RIN 0648-XA811

Takes of Marine Mammals Incidental to Specified Activities; Taking Marine Mammals Incidental to an Exploration Drilling Program in the Chukchi Sea, Alaska

ACTION: Notice; issuance of an incidental harassment authorization.

Figure 1. Source levels in 1/3-octave bands for the drillship Discoverer and ice management surrogate vessel (the ice handler Maersk Rover).

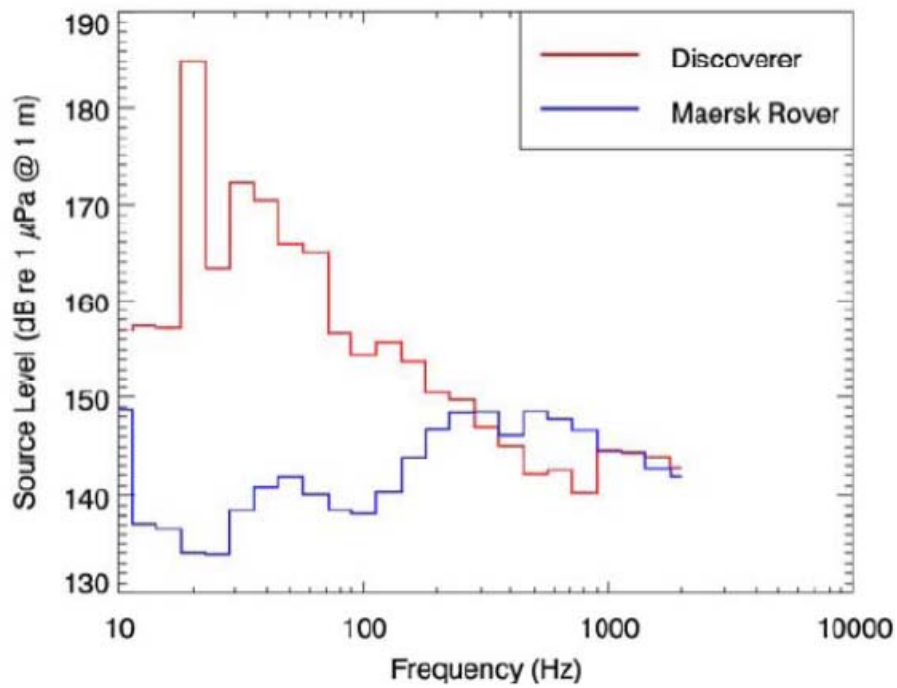
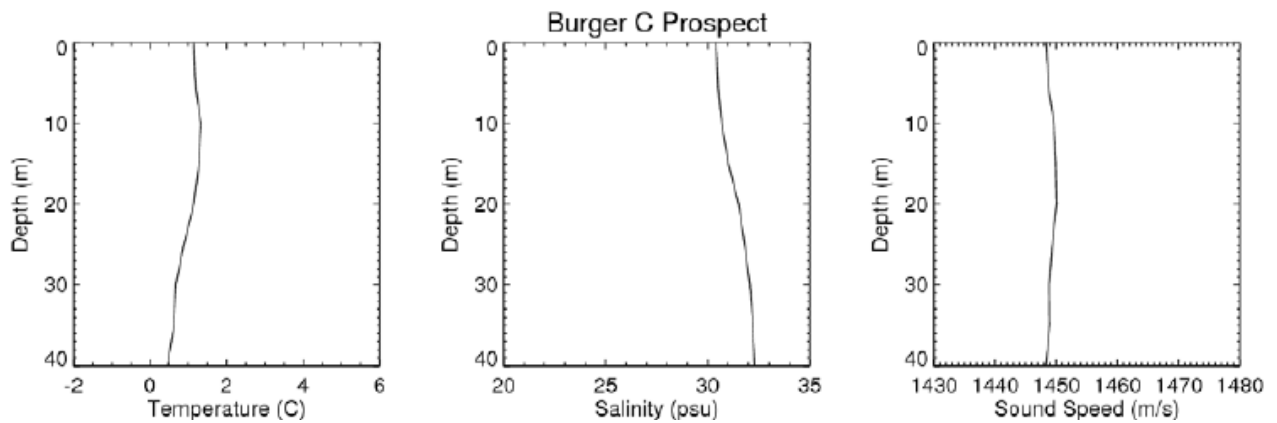
Comment 29: Dr. Bain states that the correction factor of 1.5 applied to the distance to the 120 dB contour is inadequate to conservatively account for the variability.

Response: The concern raised here is that the sound speed profile used for acoustic modeling of drill rig noise may not account for changes to the salinity and temperature profile that could influence and create variability in sound propagation, and the resulting variability might lead to conditions in which model estimates would not be conservative. The location-specific sound speed profiles considered for this modeling study were obtained from the GDEM database for conditions in July and October. A modeling study (Johnston et al., 2009) investigated the difference in sound propagation for both months and showed longer-range sound propagation using the October profile. To be precautionary and to avoid underestimating the propagation, the modeling at the Burger prospect that was used for marine mammal effects assessment was conducted using the October profile (see Figure 2). Therefore, a correction factor of 1.5 is appropriate in this circumstance.

Figure 3. Band levels for the Kulluk during drilling.

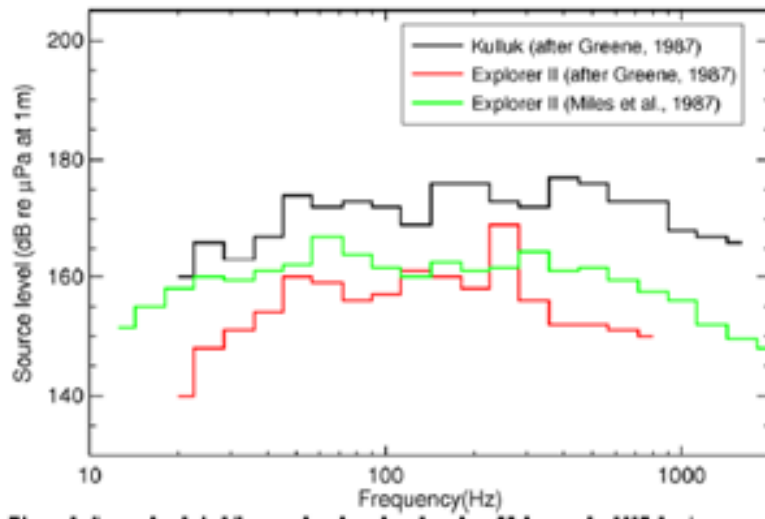
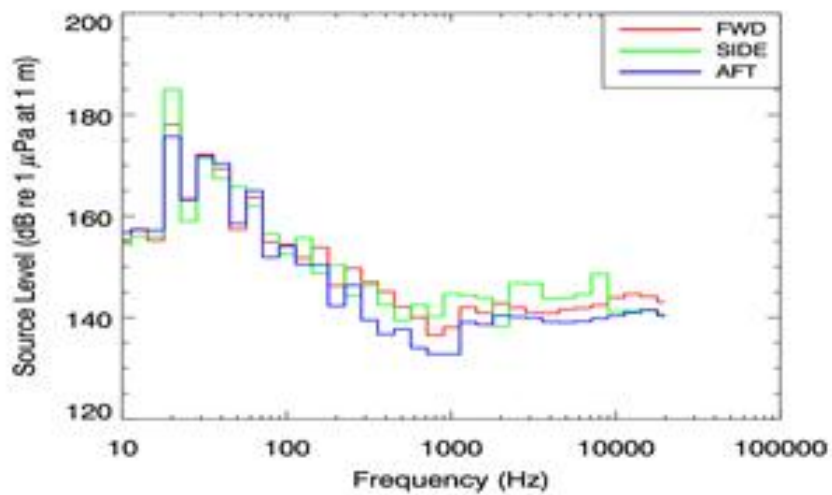
Comment 37: The NSB and AWL note that the modeled 120-dB isopleths for the Discoverer are different in the Beaufort and Chukchi Seas (with the isopleth being slightly smaller in the Chukchi Sea). Additionally, they question if the 120-dB isopleth for the Discoverer is correct given its nearly identical source level to the Kulluk drill rig (proposed for use in the Beaufort Sea), for which sound propagates out to the 120-dB isopleth at a much farther distance. If the modeled propagation is incorrect for the Discoverer, then this would bias the

Response: The primary reason for the difference in the distance of the 120 dB isopleths for the Discoverer in the Beaufort Sea vs. the Chukchi Sea is due to differences in the geoacoustic parameters for the two seas that were input to the model. Water depth, seabed density, and seabed sound speed are generally the most important parameters that influence sound propagation.

Differences in sound propagation from the two rigs are real and are caused by differences in the design of the two vessels. While the broadband source levels for the Discoverer and Kulluk may be similar, their spectral properties differ considerably. Acoustic modeling considers the source levels in 1/3-octave frequency bands. Figures 3 and 4 show the band levels for both drillships during drilling. Of key importance are the significantly lower levels of the Discoverer in the 50 to 500 Hz bands that propagate well in the relatively shallow waters of these drilling operations. While the Discoverer apparently has higher band levels below 50 Hz, this energy is more rapidly attenuated than higher frequency sound energy. This characteristic of sound propagation in shallow waters leads to predominantly mid-frequency sounds (50-500 Hz) dominating the acoustic field at distance from the drillships. A further consideration is that the Kulluk source levels are known to include contributions from support vessels, and much of the mid-high frequency band energy in its source levels may not originate entirely from the drillship itself, as acknowledged by Greene (1987). The Discoverer source level measurements by Austin and Warner (2010) were made at closer distances and do not include significant contributions from other vessels. Additionally, the IHA requires Shell to conduct sound source verification and characterization tests on all equipment used.
